NEW
RIVER

Burgess Hill

Design & Access Addendum

Proposed Section 73 Amendments

Proposed Ground Floor Plan - Level 01

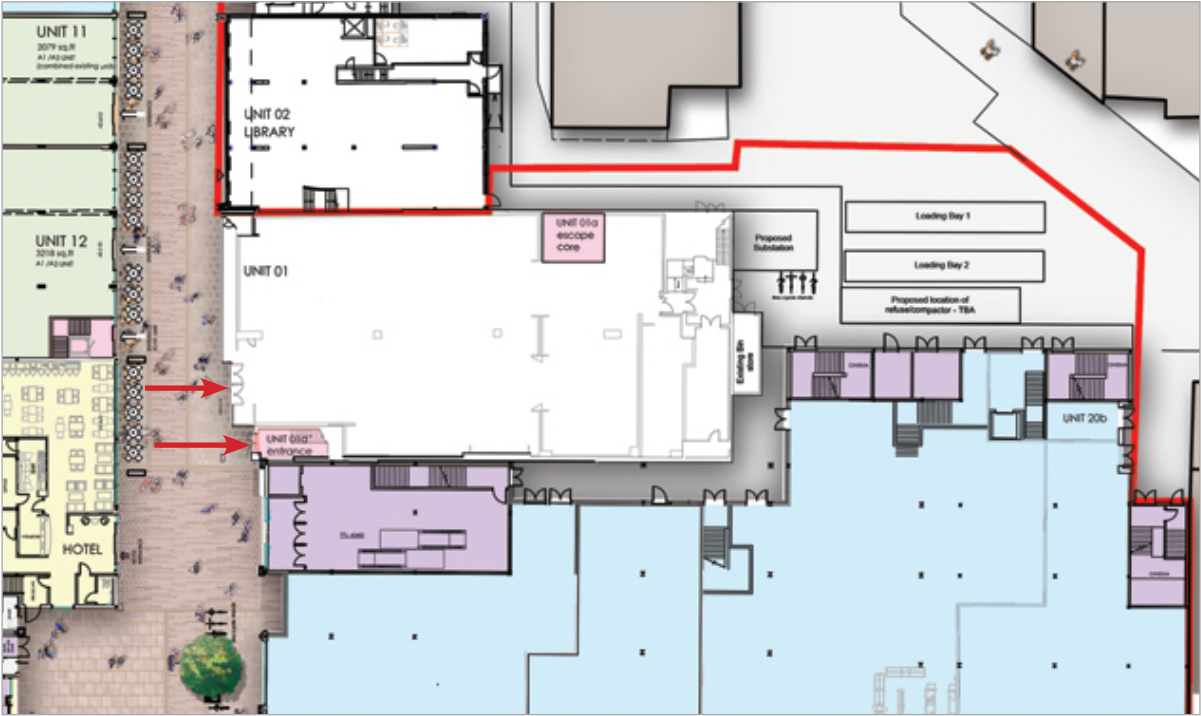
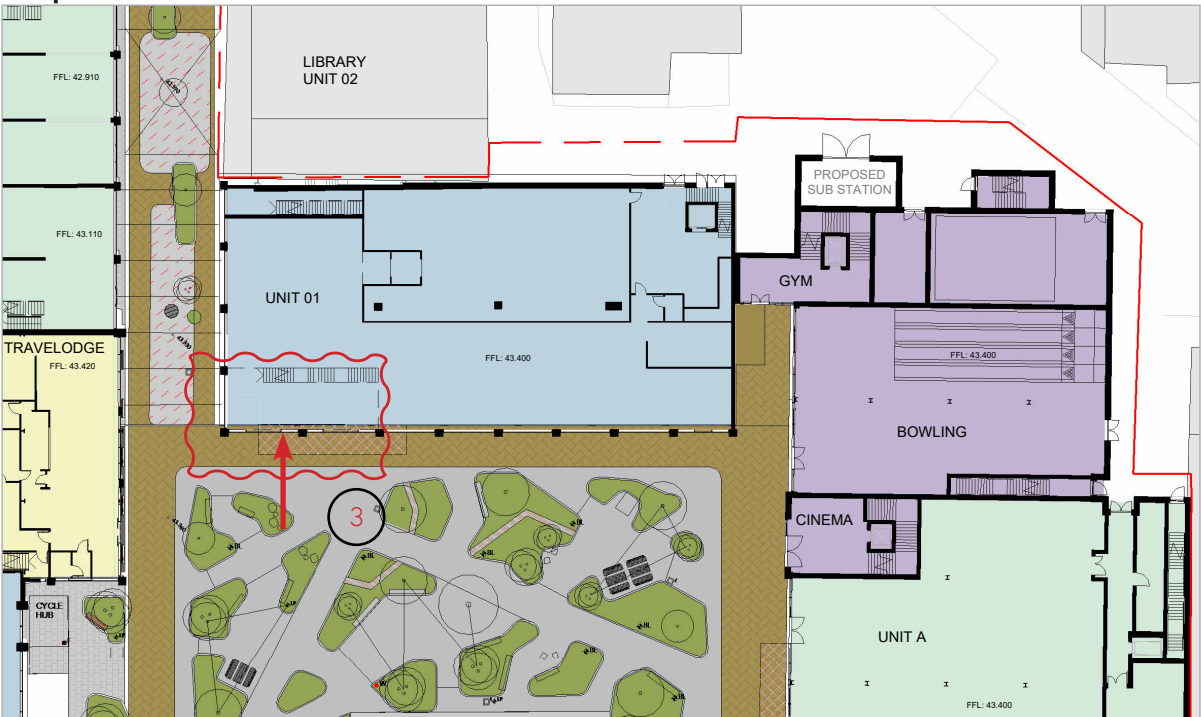
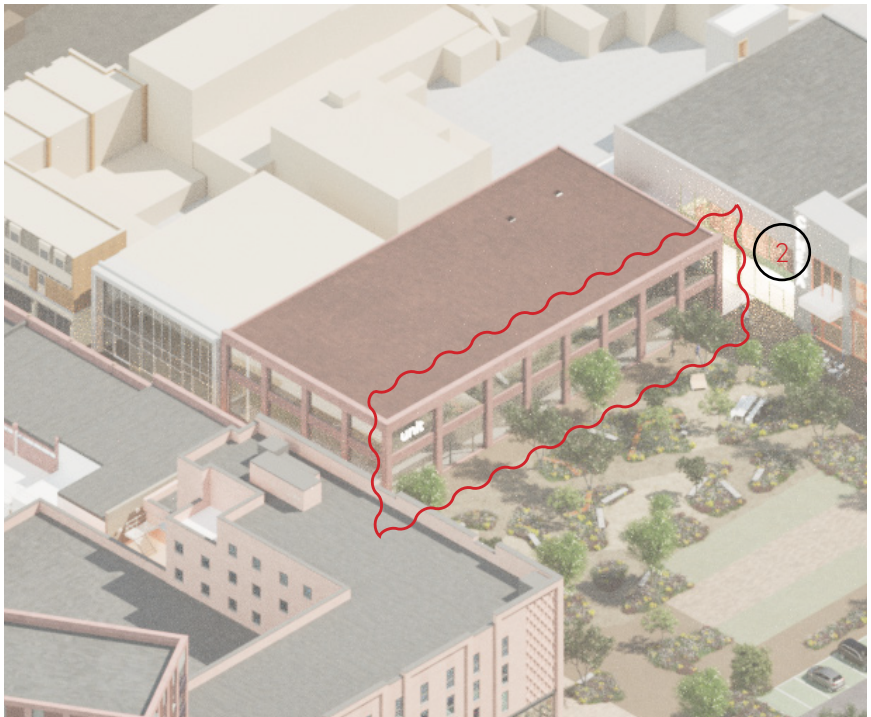
- 1. The consented scheme allowed for 2 separate retail units - Unit 01 at Ground Floor and Unit 01A which was a separate unit at first floor which direct access from ground level. The revised proposal combines both units to provide a larger retail unit over 2 levels.

- 2. In the consented proposal the new multiplex cinema/retail building directly abutted the boundary wall of Unit 01. The cinema entrance was adjacent to the Unit 01a entrance. As a result Unit 01 had frontage to on its North Western Elevation only. With the reduction to the leisure block massing and the revised positioning, as outlined above, the South Western boundary of Unit 01 will no longer abut to a building. Unit 01 will now have store frontage along the length of its South Western facing elevation, fronting onto the new public realm.

- 3. Both Units 01 and 01a were previously accessed from Church Walk opposite the Hotel & Unit 12. With the above changes, the store entrance is relocated to the south western side to optimise the revised layout and relationship with the common. The separate entrance lobby to the staircase leading to the first floor is demolished and a large atrium opened up over the store entrance in line with tenant preferences.

Proposed Section 73 Amendment

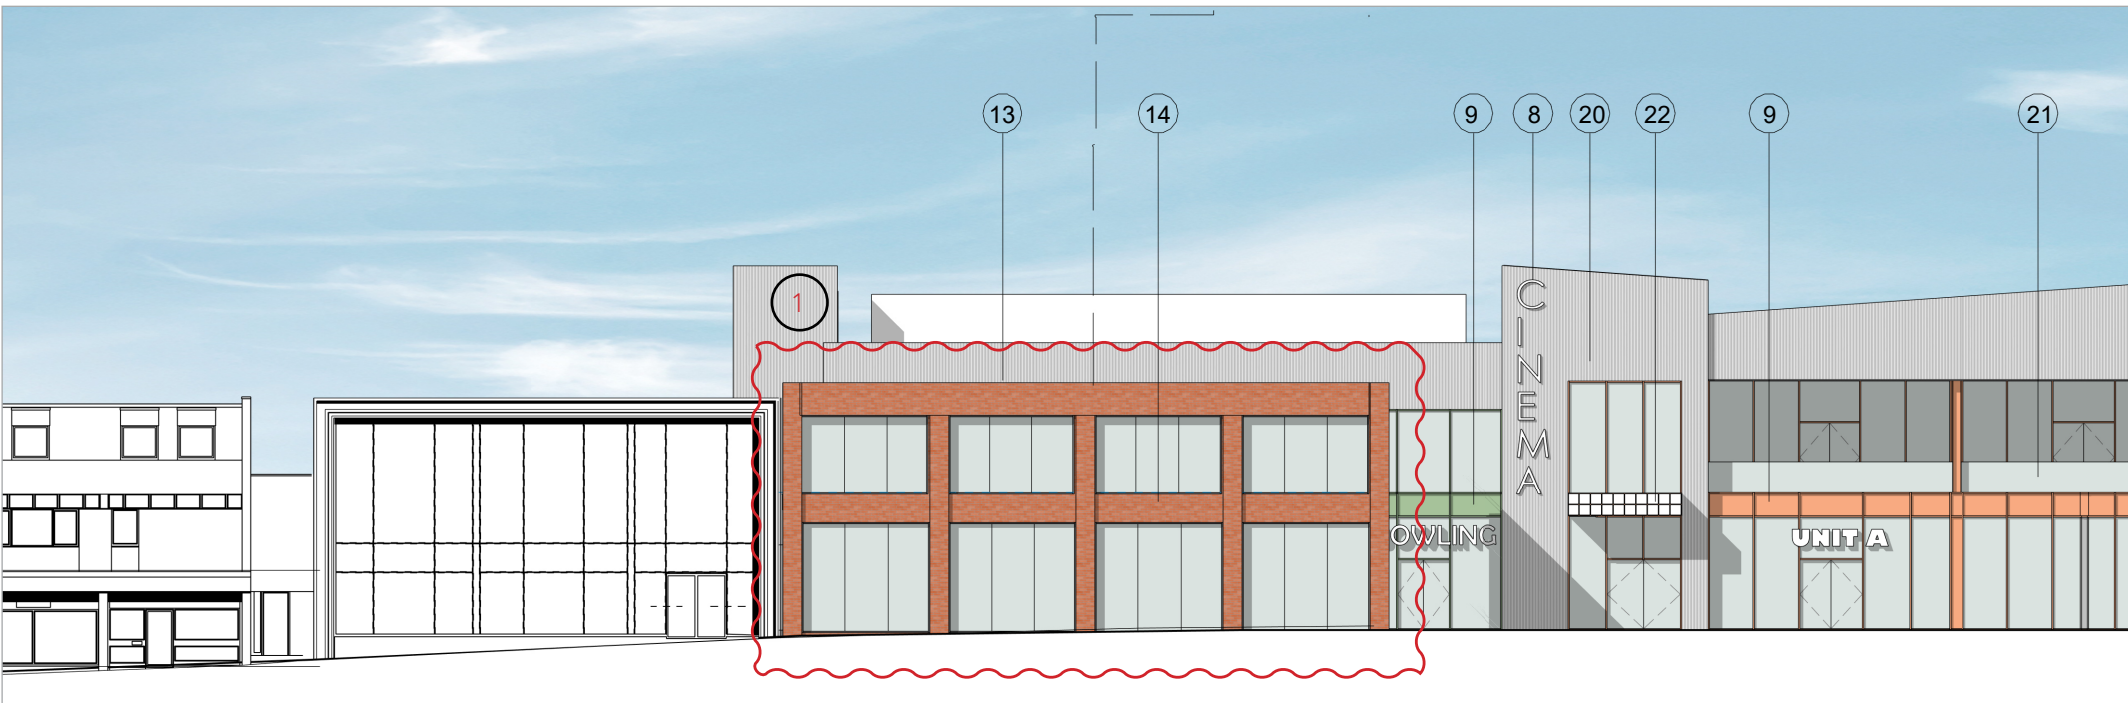
- 1. The consented scheme included for a new shop front on the North Western elevation adjacent to the recently completed Library. The elevational treatment included a fully glazed shopfront at ground level, aluminium framed window and dark grey stone effect cladding at first floor level and a stone effect frame to the whole façade. This language united the shop front with the new cinema block as well as the shopfront of the new food store opposite. The revised proposal includes for the necessary demolition and refurbishment works to provide new shop fronts to both the North Western and South Western elevations. With the above outlined changes to the units site positioning and connection of the ground and first floor units the façade language has been informed by the new shopfronts to the other retail units along Church Walk (Block A2). Red brick piers with stone capping details form bays to break the shop frontage vertically, and new floor to ceiling glazing is provided at ground and first floor.

Proposed Landscaping Plan - Level 01

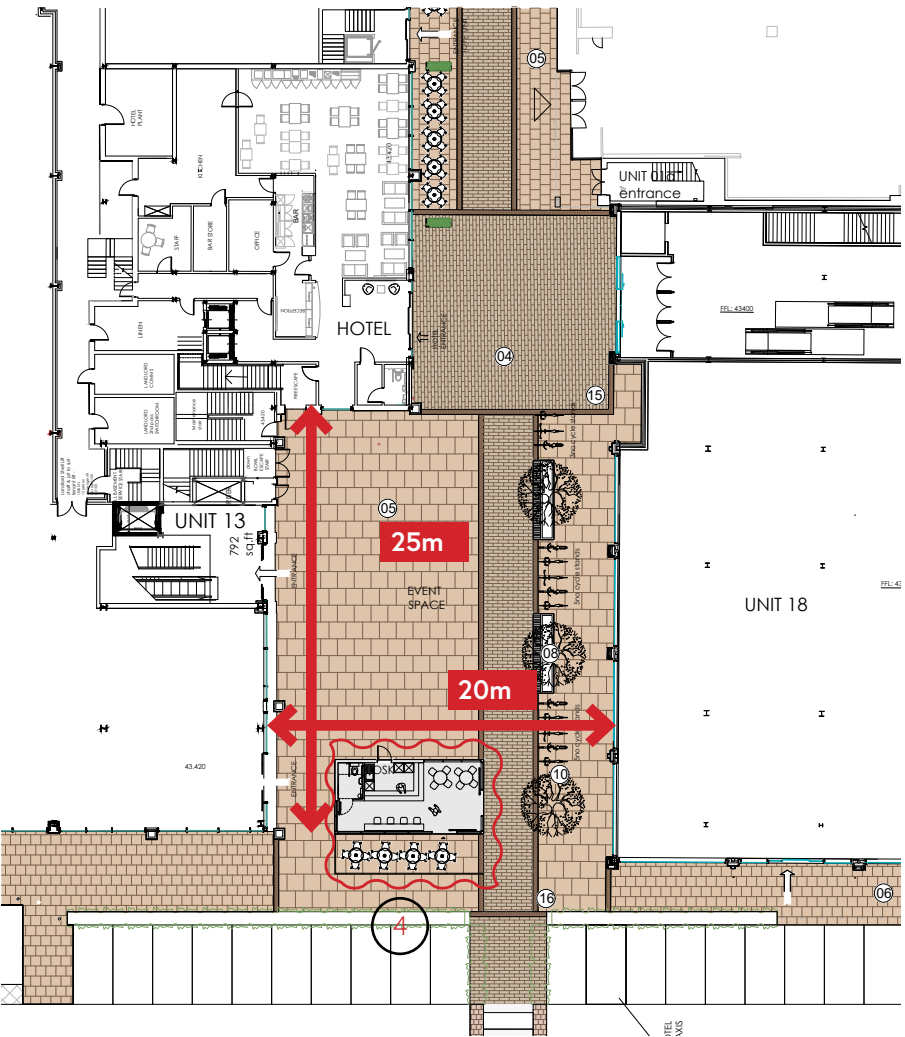
- 1. In the consented scheme the new square, noted as Event Space on the approved plans, was a widened portion of Church Walk to the South western end of the retail arcade as adjoining the car parking zone. This public square was 20m wide and 25m deep. In the revised proposal the reduction of the leisure block (Block B2) facilitates the widening of this area creating a more meaningful public square, now called The Common. The Common is 63m wide and 45m deep.

- 2. The public square of the current scheme is enclosed by entrances to the hotel, bowling alley, maintenance stair, retail uses and the entrance to the cinema. In the revised scheme there is increased frontage onto the public realm, providing greater activation to this vital space. The Bowling alley, Cinema, Gym, retail spaces, food store, hotel and food & beverage are all access to/from the common.

- 3. In the consented scheme the new square was hard landscaped with a variety of large and small paving in warm buff zones. By contrast the increased scale of the common facilitates a wide variety of space, with a mixture of hard and soft landscaping, and notably enhanced greening of the public realm of Burgess Hill. The landscaping strategy incorporates play spaces, seating areas, flexible event zones and lounging lawns amongst dense planting, trees and informally planted edges.

- 4. In the consented application a glazed kiosk building is located on the south western edge of the square. This is omitted in the S73 application in favour of the above listed variety of spaces created within the landscape.

Proposed Landscaping Plan - Level 01

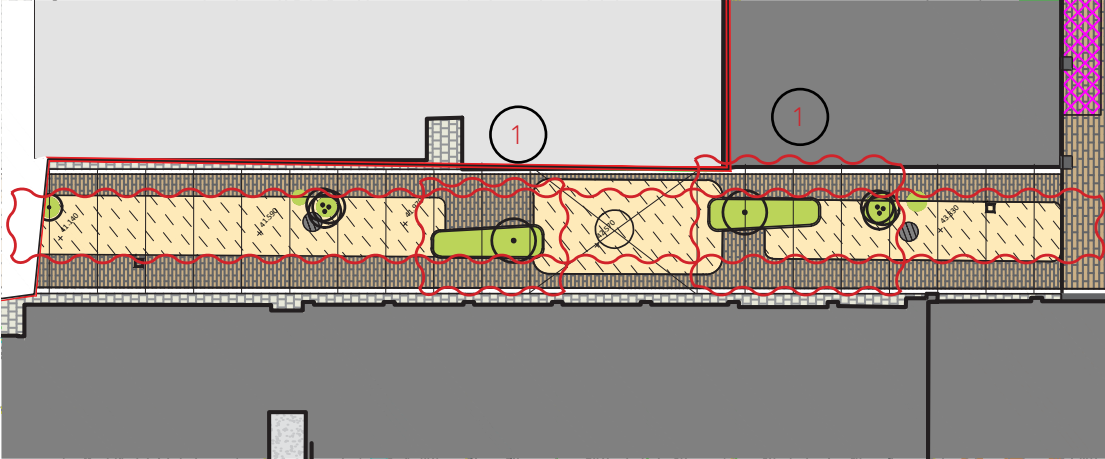
- 1. In the consented application the retail street connecting the public square and Church Walk is hard landscaped in the same warm buff paving. The revised application introduces soft landscaping by way of small pockets of greenery and trees to break down the space.
- 2. The revised proposal develops this area of Church Walk, between the Common & The Bandstand into a dynamic passage. A creative floorspace, drawing on local materials, patterns and vernacular references is applied underfoot, whilst overhead lighting creates a more intimate scale. All of the interventions are designed to complement the active frontages of the local retail units.

Proposed Landscaping Plan - Level 01

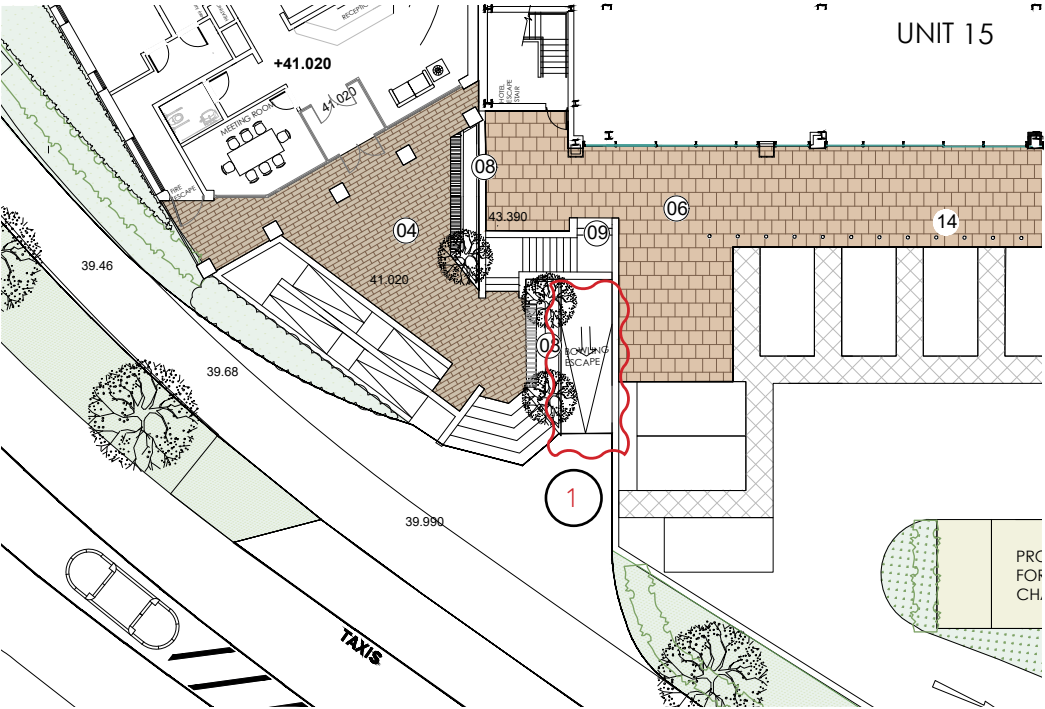
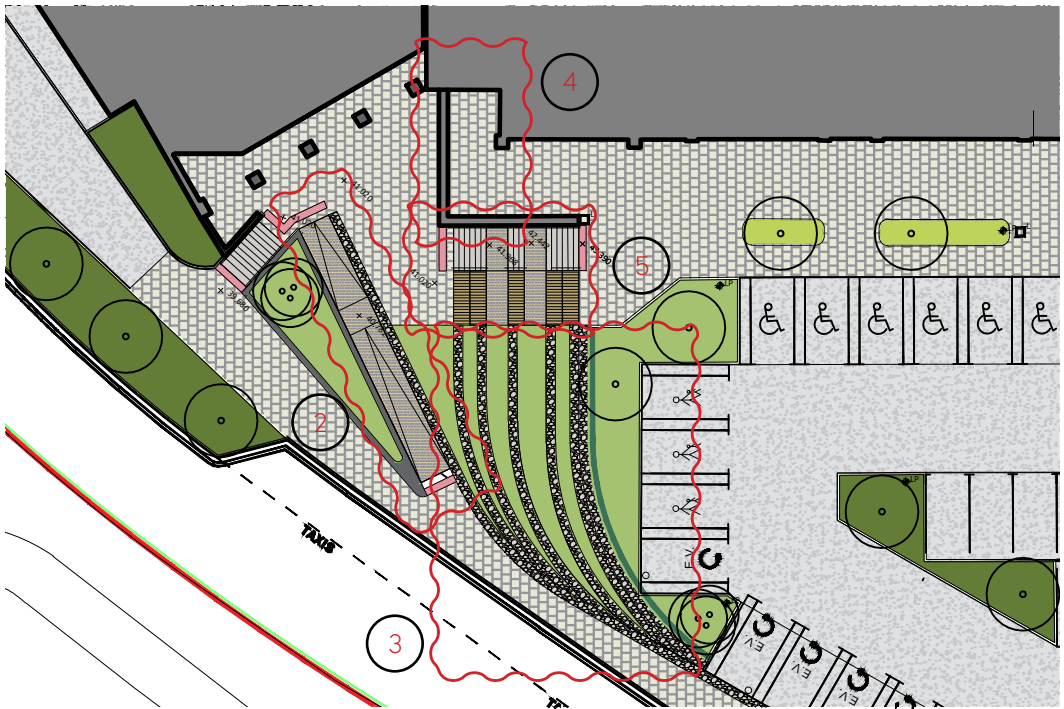
The junction between the main entrance to the residential block (Block A1) and the south western corner of the car park covers a fairly significant level change. The consented application also had an exit route from the basement bowling alley below the landscaping, which discharged onto Civic Way. With the relocation of the Bowling Alley into Block B and omission of basement conversion this exit point is no longer required in the revised application.
2.

The consented application included a dog legged ramp to provide an accessible route from Civic Way to the ground floor level of the residential block. With the omission of the bowling alley access route the ramp is revised to a straight run that works with the natural topography of the site.
3.

Gabion steps, planted at each level with wildflowers, replace the vertical retaining wall adjacent to the car park. Sweeping around the corner this landscaping intervention significantly softens the edges of the scheme and greens the boundary of the Car Park and Civic Way.
4.

In the proposed updated scheme, the retaining wall between the Hotel escape stair (adjacent to the food store shop front) and the residential entrance has been pulled back away from the residential entrance to provide more breathing space to the ground floor lobby of Block A1 and ensure improve the security of the balcony on the first floor adjacent to the hotel escape.
5.

In the consented scheme an S-shaped external staircase connected the residential ground floor level directly to the main external car park and public realm level. In the revised scheme this stair is adjusted to a straight run with improved destination visibility. The staircase also incorporates public seating, optimising the south facing orientation and enhance the landscaping offering for both the public and residents.

Proposed Landscaping Plan - Level 01

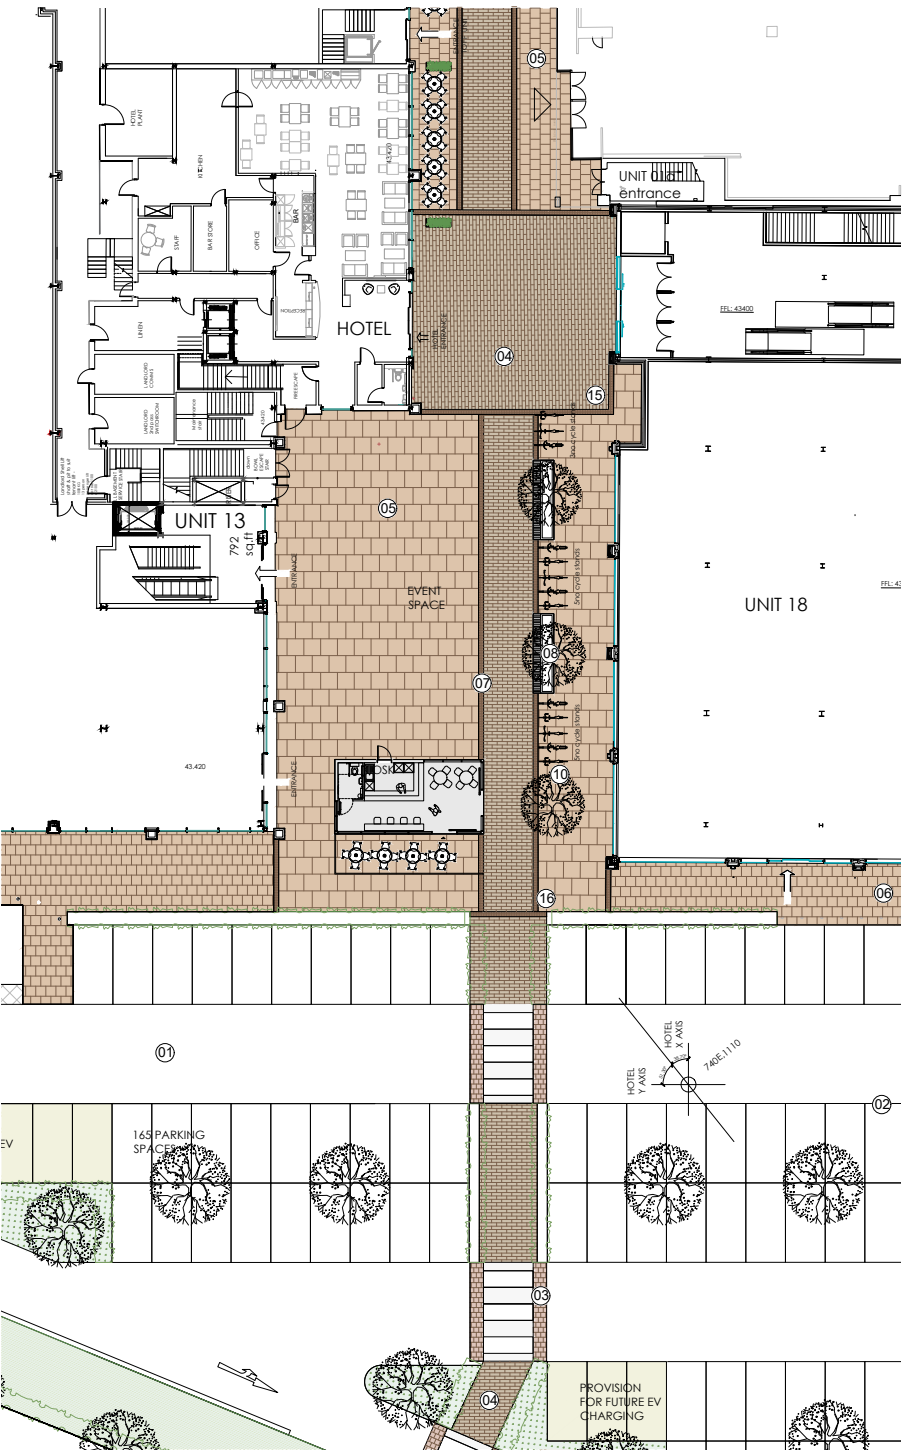
- 1. In the consented planning application the Civic Way Car Park provided 171 spaces, created by way of an extension to the existing Martlets Car Park. This revised proposal seeks to increase the parking provision in the Civic Way Car Park to 197 spaces. The 26 additional spaces will be allocated to residents of Block A1, these spaces account for those no longer allocated in the lower ground of Block A1. The total number of parking spaces across the whole scheme remains unchanged as 242 spaces.

- 2. In the consented application the Civic Way parking followed the same South Western boundary as the existing neighbouring parking, remaining south of the public square. In the revised proposal 17 spaces are integrated into the landscape of the public realm, extending the parking northwards into the Common. These spaces are will be softer, through the use of grasscrete and soft planted edge, forming a transition to the rest of the common. This area of parking is flexible and could also be used to host events like farmer's markets, outdoor cinema screenings or gym classes as the town centre of Burgess Hill evolves.
